UNITED STATES PATENT AND TRADEMARK OFFICE

APPLICATION NO.	FILING DATE	FIRST NAMED INVENTOR	ATTORNEY DOCKET NO.	CONFIRMATION NO.
10/511,911	08/18/2005	Ib Joergensen	31698-2030	4306

Office Action Summary	Application No.	Applicant(s)	
	10/511,911	JOERGENSEN ET AL.	
	Examiner	Art Unit	
	LoAn H. Thanh	3763

DETAILED ACTION

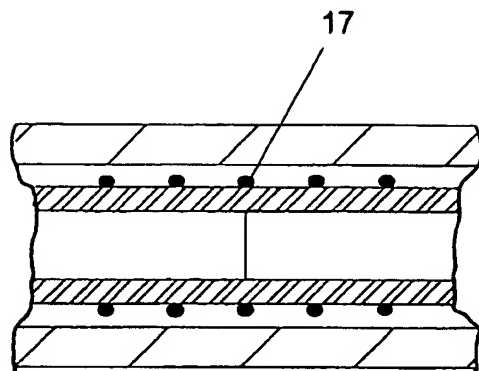
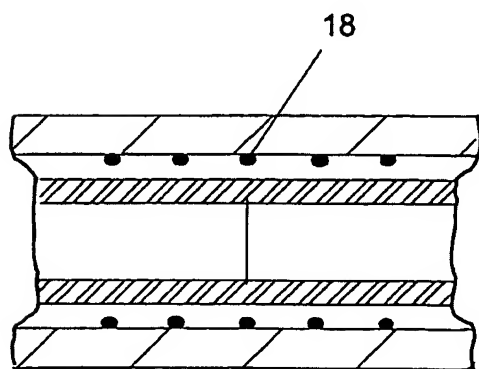
The new drawing has been approved. However, the drawing objection with respect to the coating is still maintained.

The drawings are objected to under 37 CFR 1.83(a). The drawings must show every feature of the invention specified in the claims. Therefore, the coating (claims 13,23,26) must be shown or the feature(s) canceled from the claim(s). No new matter should be entered.

approved
9/5/16
